Item ID: D212-664-101TRN

Item Name: Crosstube Turning Detail

DART AEROSPACE LTD		Work Order:	93994
Description: Crosstube Assembly (205/212/412 High Fwd)		Part Number:	D212-664-141
Inspection Dwg: D212-664-141 Rev: D		Page 1 of 2

DRAWING NO. D212-664-141	TITLE XTUBE ASSY (205/212/412 HI FWD)	REV. D	DART AEROSPACE LTD ENGINEERING ORDER		D.E.O. NO. D212-664-141-D-1	SHEET NO. SHEET 1 OF 2	SCALE NTS
DRAWN	CHECKED	MFG. APPR.	APPROVED	DE APPR.			
DATE 11.04.07	DATE 11.07.11	DATE 11.04.12	DATE 11/04/12	DATE 11.04.12

**D212-664-141/-141B
ASSEMBLY DETAIL**

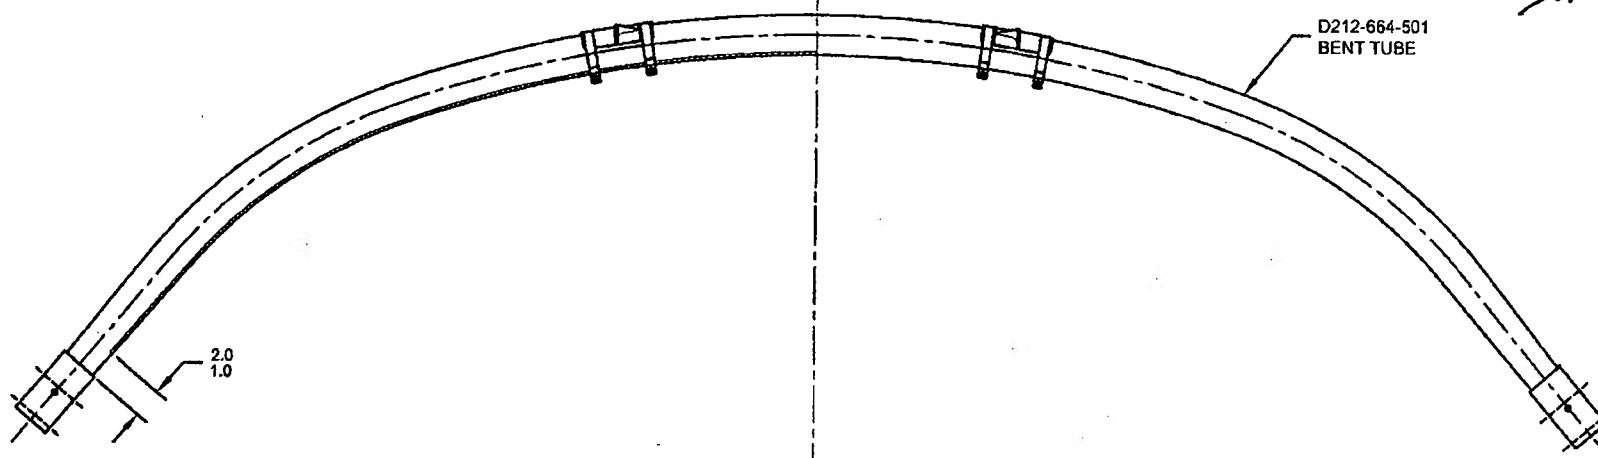
PURPOSE:

ADD AN INSPECTION WINDOW TO UNDERSIDE OF CROSSTUBE.

NOTES 2 OF SHEET 1 IS AMENDED AS FOLLOWS:

IS:

WAS:

- 2) FINISH: CHEMICAL CONVERSION COAT PER DART QSI 005 4.1
PRIME INSIDE AND OUTSIDE PER DART QSI 005 4.2
MASK UNDERSIDE OF CROSSTUBE AS SHOWN (HATCHED AREA) AND
PAINT OUTSIDE PER DART QSI 005 4.2
REMOVE MASKING AND APPLY CLEAR COAT

MASK AREA PRIOR TO PAINTING.
REMOVE MASKING AFTER PAINT
AND APPLY CLEAR COAT
